MODEL CT-2177DT/DTN/FN/UKTN

SCHEMATIC DIAGRAM AND P.C BOARDS

CT-2177 DT/DTN/FN/UKTN
CTV Schematic diagram
No. QF002 F 301

POWER SUPPLY

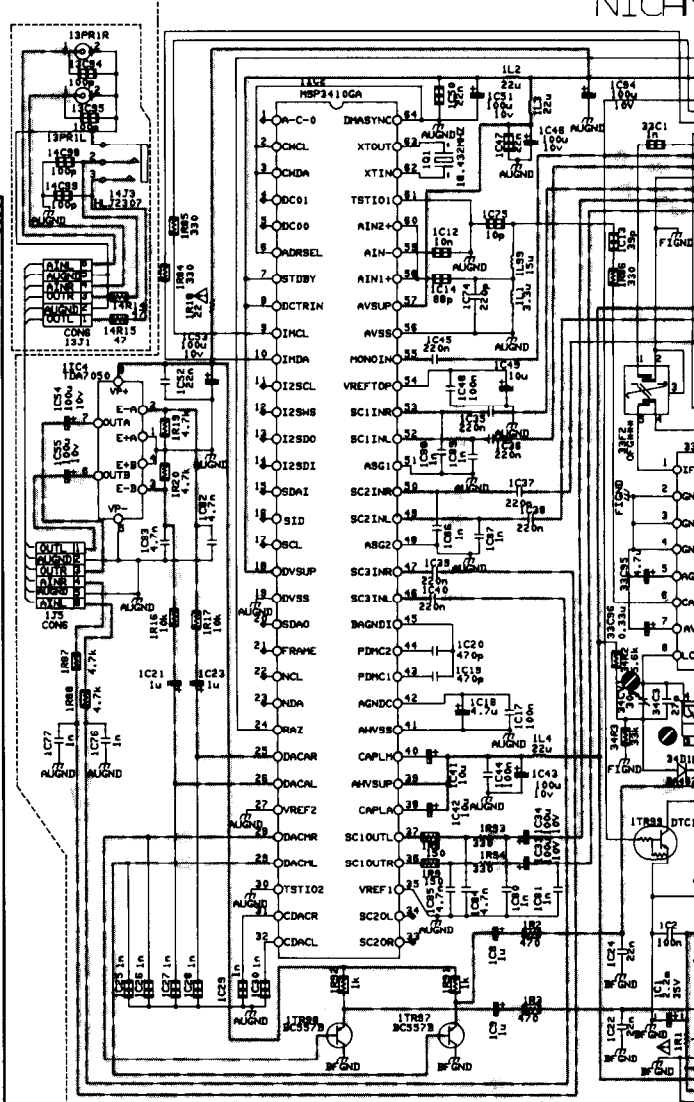
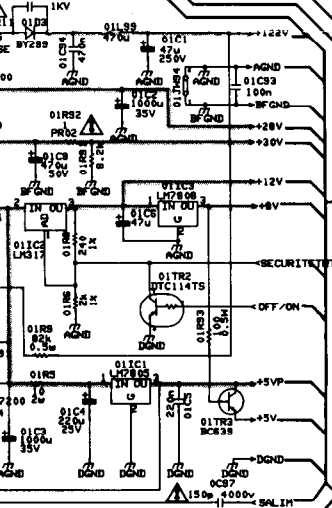
Fuse Blown

Change Thermister New P.No .ER-440563F
+ New fuse Type

NICAM

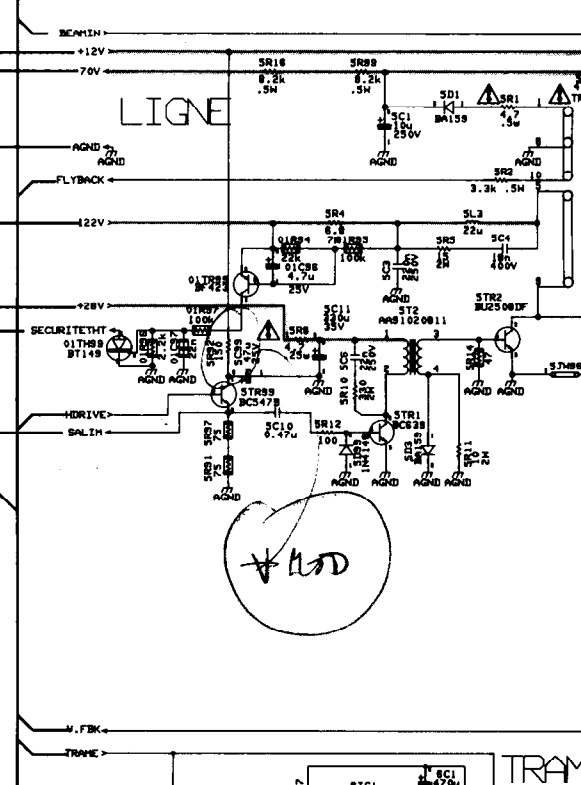
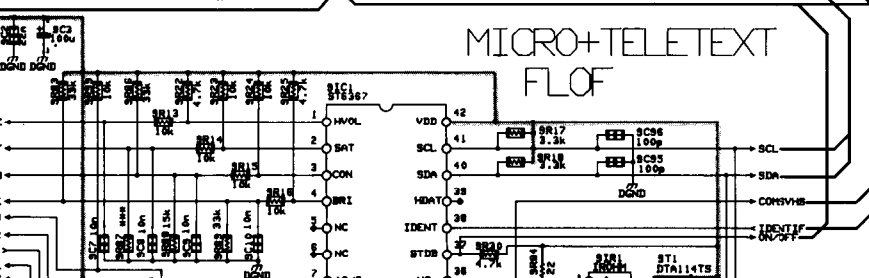
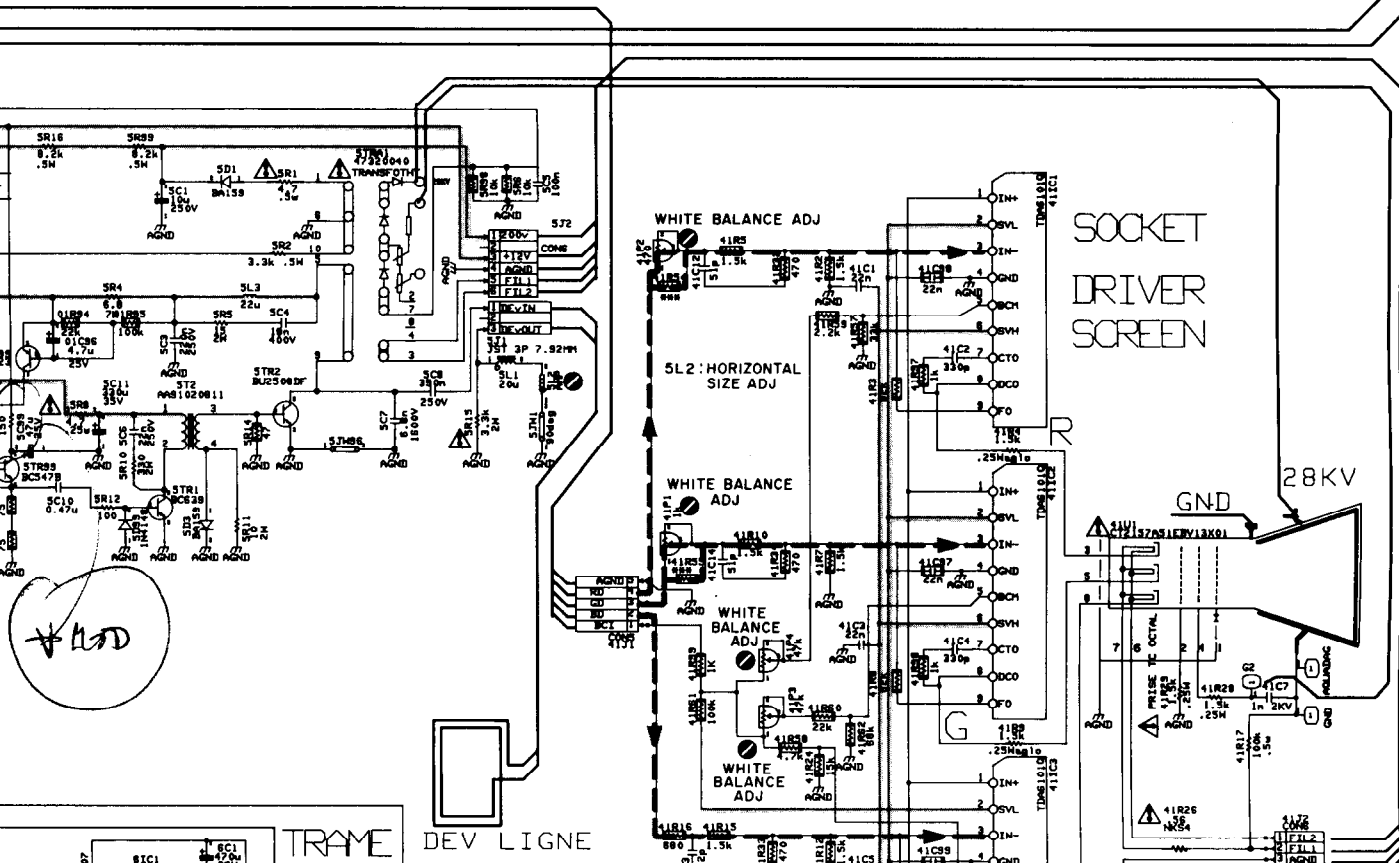
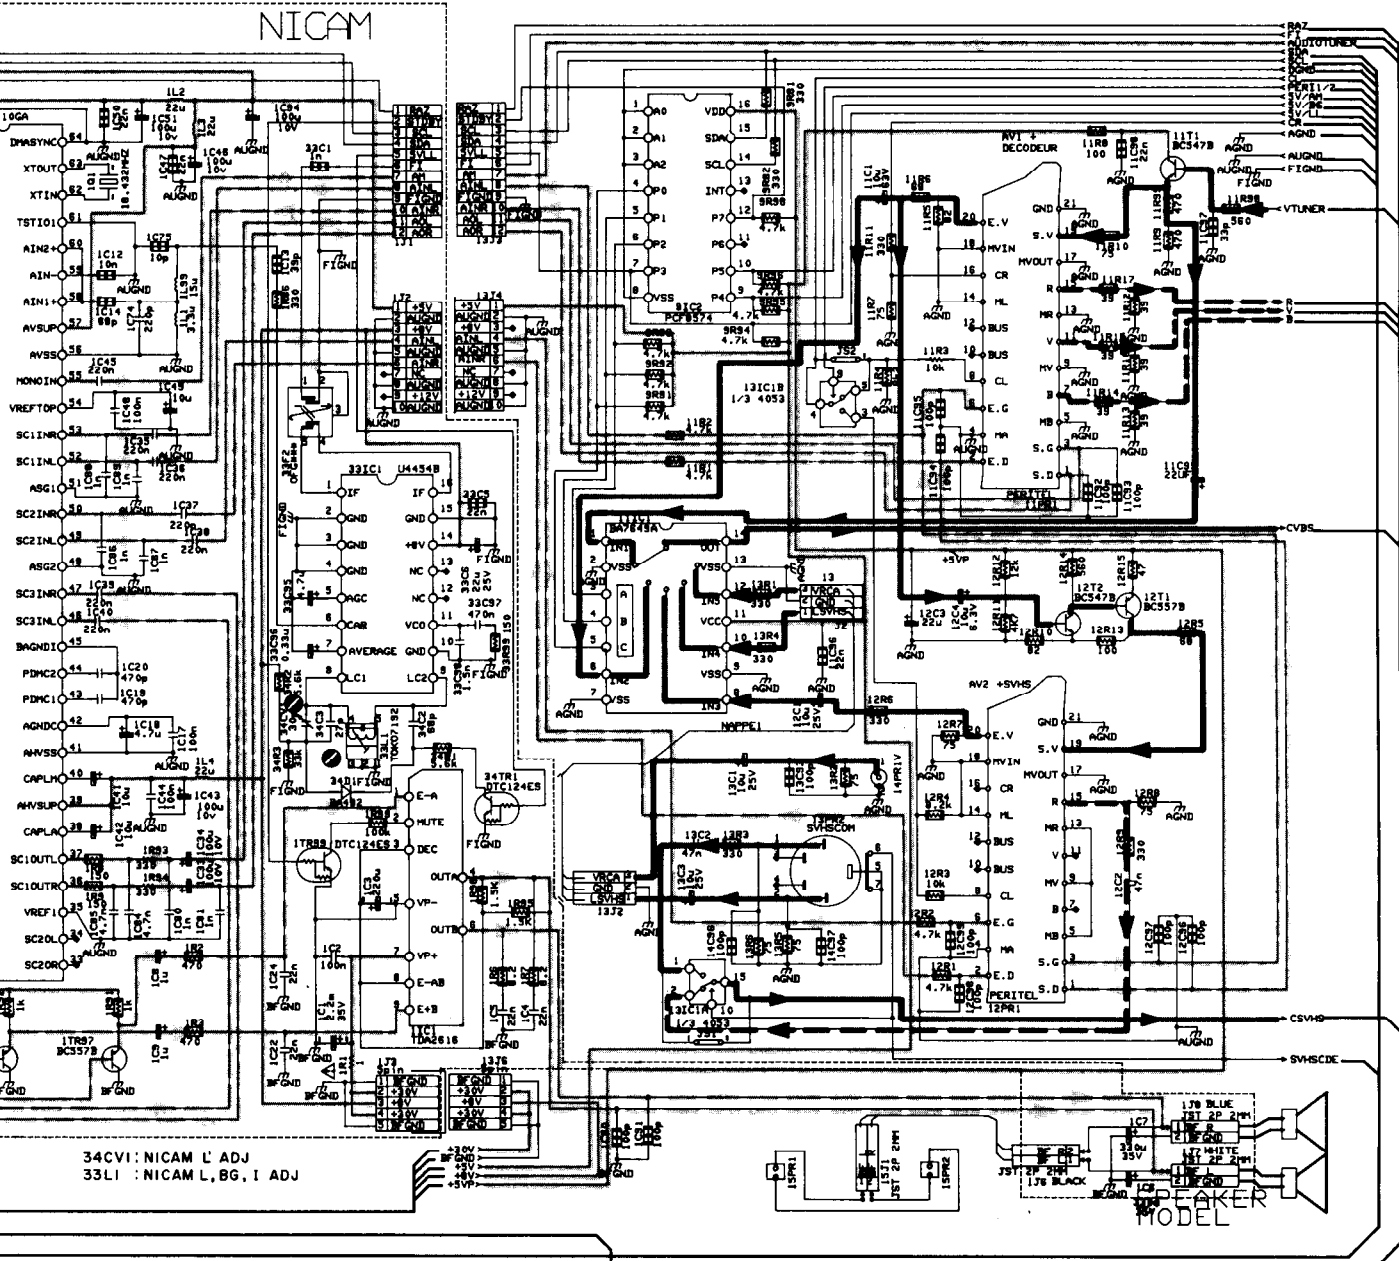
Nicam crackling →

SR92 220K → 120K

SR96 11K → 2.2K

LINK JW114 NEAR 91C1

01 IC3 SOLDER PATH TO CHASSIS (REC IC)
